Determination 2015/031

The refusal to issue code compliance certificates for a 12-year-old shop/dwelling and an 8-year-old toilet block, and alterations carried out without a building consent at 2515 Oxford Road, Oxford

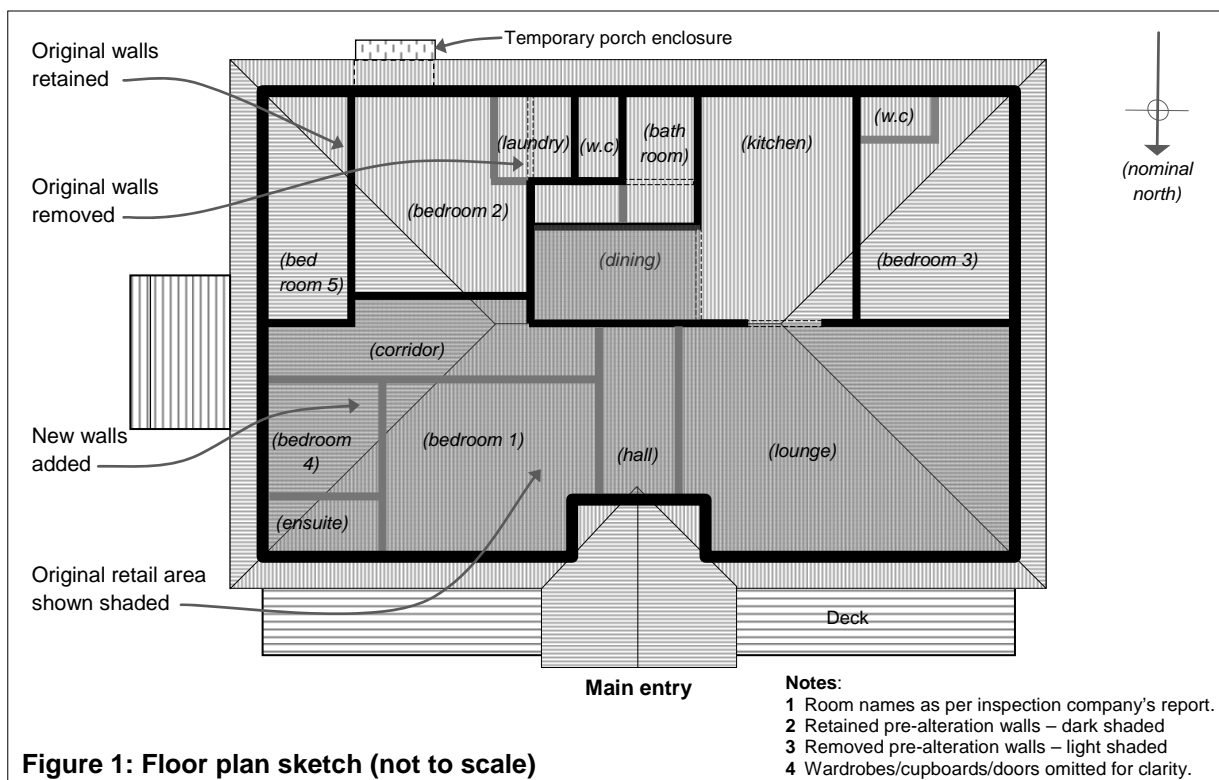
2.2.2 Interior alterations were carried out from 2010 to 2013, which changed the as-built shop/dwelling into a five bedroom dwelling as shown in Figure 1:

2.2.4 The recent alterations included:

- subdivision of the original open shop area to provide a new lounge, master bedroom (“bedroom 1”), ensuite bathroom, a small bedroom (“bedroom 4”), entry hall and corridor
- partition to small storeroom removed and doorway to shop closed up
- opening added to original wall separating retail and dwelling areas
- conversion of the lounge into a bedroom (“bedroom 2”)
- a toilet added to the southeast bedroom (“bedroom 3”)
- extension of the original shower room to provide a laundry
- extension of the original bathroom to accommodate a shower.
